2023 Polling Site Accessibility Report: Marion County, WV

On August 1 and 2, 2023, a DRWV Advocate completed exterior accessibility monitoring of all precincts in Marion County and this report contains our findings. The following ADA codes referenced below are the most common issues noted in this county.

First Baptist Church

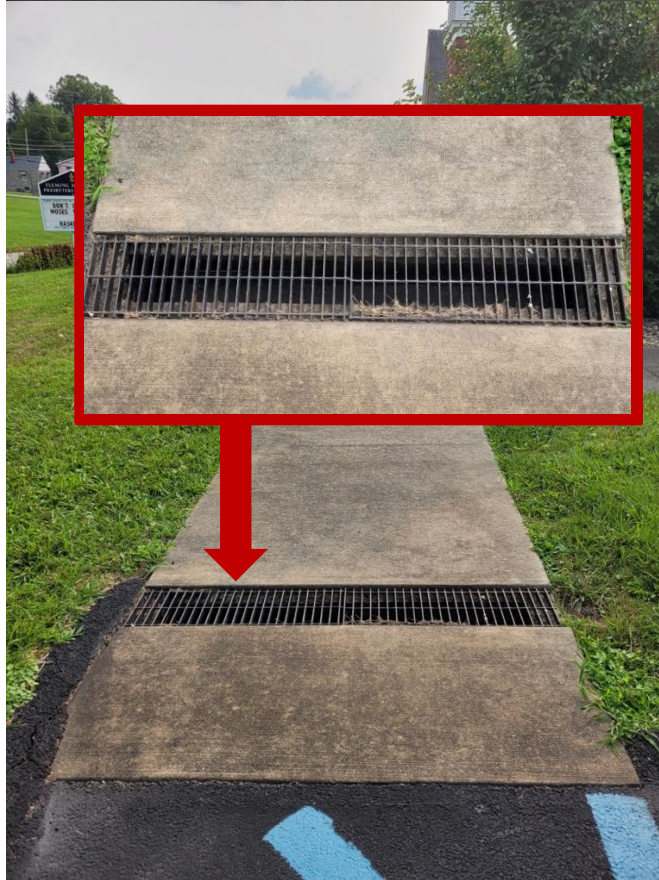
Issue(s) The existing accessible parking signage is not displayed at the proper height (502.6). There are not clearly defined access aisles for each accessible parking space (502.2, 502.3). There is no parking space designated as van accessible (502.2). The door hardware is not accessible (309.4).

<p>Suggestions for ADA Compliance</p>	<p>Replace the inaccessible door hardware with a loop, push, or pull hardware. Adjust existing parking signage to the appropriate height requirement (60”) and designate at least one space to be van accessible. Install access aisles, complying with ADA Standards 502.2.</p>
--	--

Monongah Town Hall

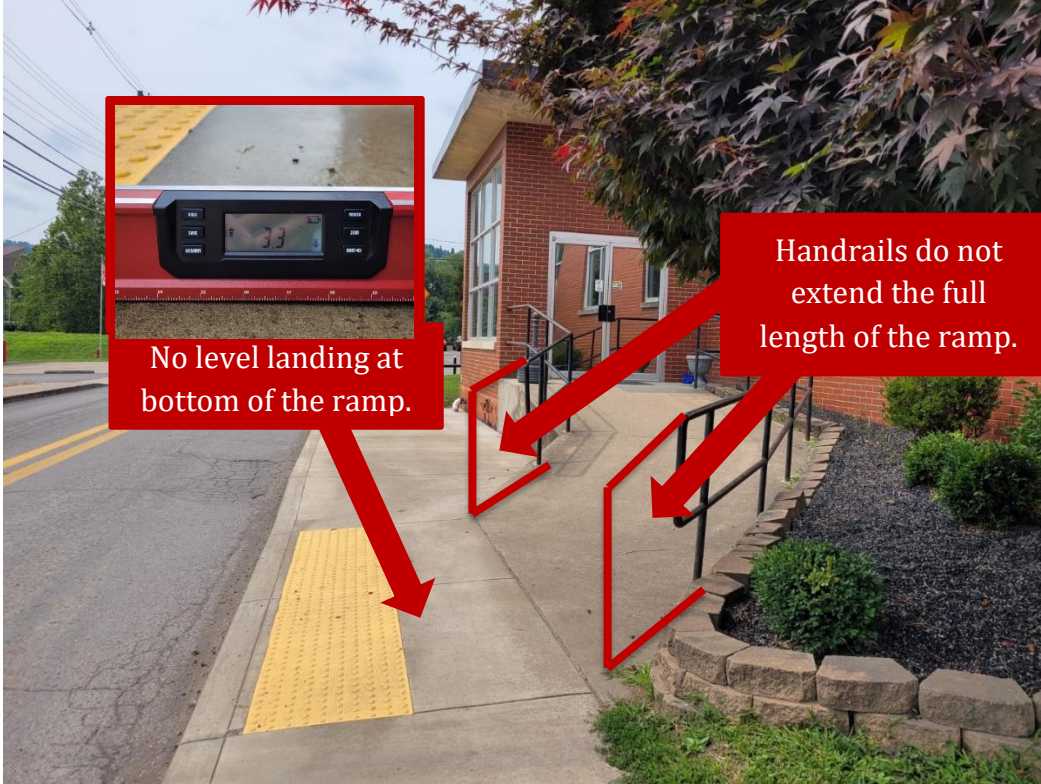
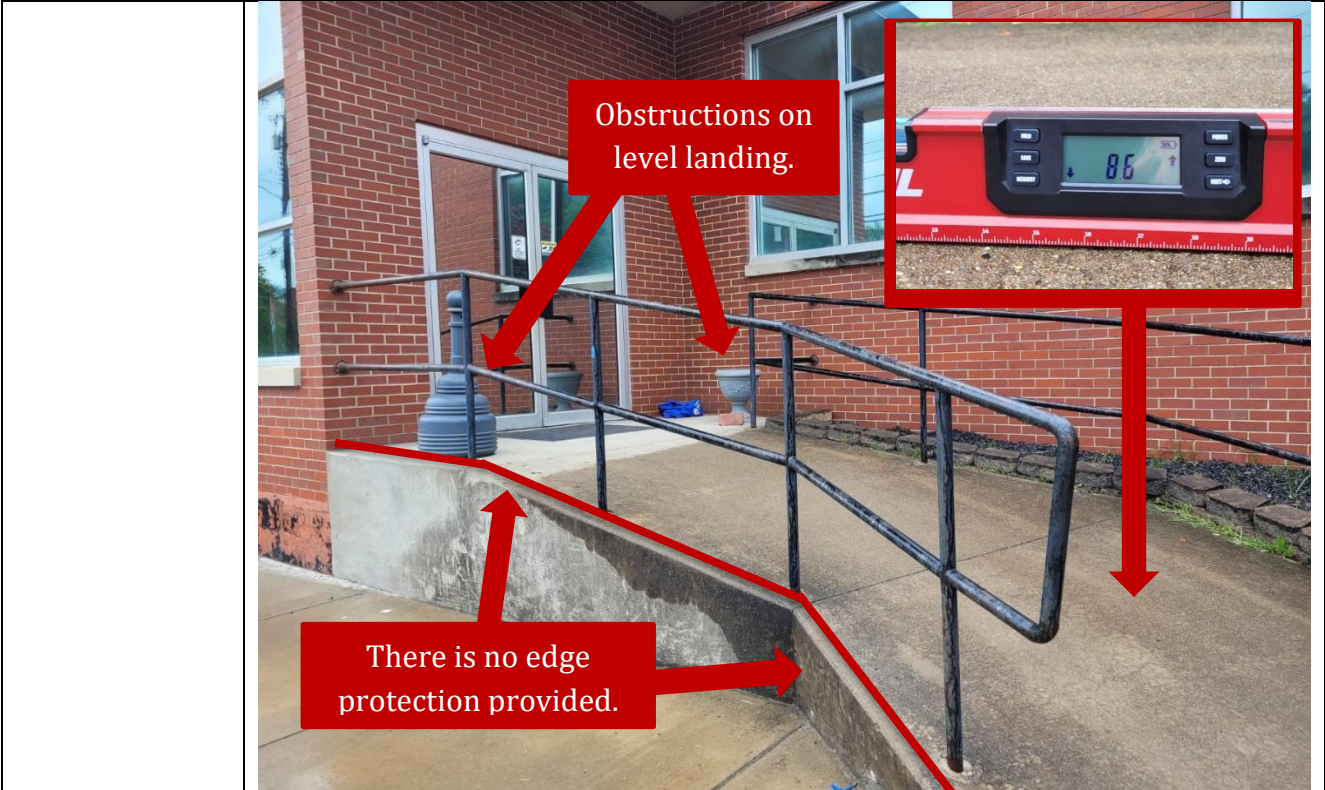
Issue(s)	Handrails are not extended to the bottom of the ramp (505.10.1). There is no edge protection on the ramp (405.9). The slope of the ramp exceeds ADA Standards; The slope runs 8.5-9.0 degrees but should not exceed 4.76 degrees (405.2). There is not a level landing provided at the bottom of the ramp (405.7). There is no accessible parking or passenger drop-off area provided (502.2).
-----------------	--

Exhibit	 <p>The photograph shows a concrete ramp leading to a brick building. A red callout box at the top left shows a close-up of a level sensor on the ramp surface, with a red arrow pointing to the ramp's end. A red callout box at the bottom left points to the end of the ramp, stating "No level landing at bottom of the ramp." A red callout box on the right side points to the handrails, stating "Handrails do not extend the full length of the ramp." The ramp has a yellow tactile strip at the bottom and a black metal handrail on the right side.</p>
----------------	---

Suggestions for ADA Compliance	Install handrail extensions and edge protection on the ramp. Ensure the ramp has a level landing, measured 60" by 60", provided at the bottom where it meets the curb ramp. Though there is still a 60" by 60" clearance on the level landing at the top of the ramp, the debris could cause obstruction to entry and should be removed.
---------------------------------------	--

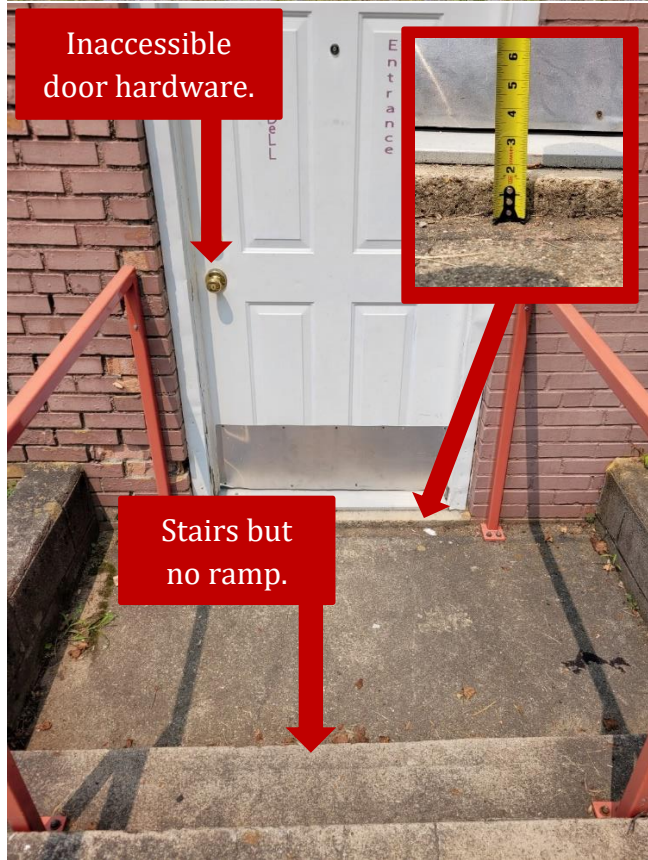
Quiet Dell Community Building	
Issue(s)	The parking facility is not stable (302.1, 502.4). The existing accessible parking signage is not visible or legible from the parking facility (502.6). The accessible parking spaces are not clearly defined (502.2, 502.3.3). Both entrances have unstable access routes (302.1). One entrance (labeled as the main entrance – white door) has only stairs and no ramp, inaccessible door hardware, and a lipped edge at the door threshold (405.1, 309.4, 303.4). The other entrance has no outer door hardware (309.4).
Exhibit

Access route is not stable. There is no ramp.

Unstable parking facility. Accessible parking is not clearly defined.

Inaccessible door hardware.

Stairs but no ramp.

Suggestions for ADA Compliance	Address the issues identified or relocate the polling place to another facility that complies with ADA Standards.
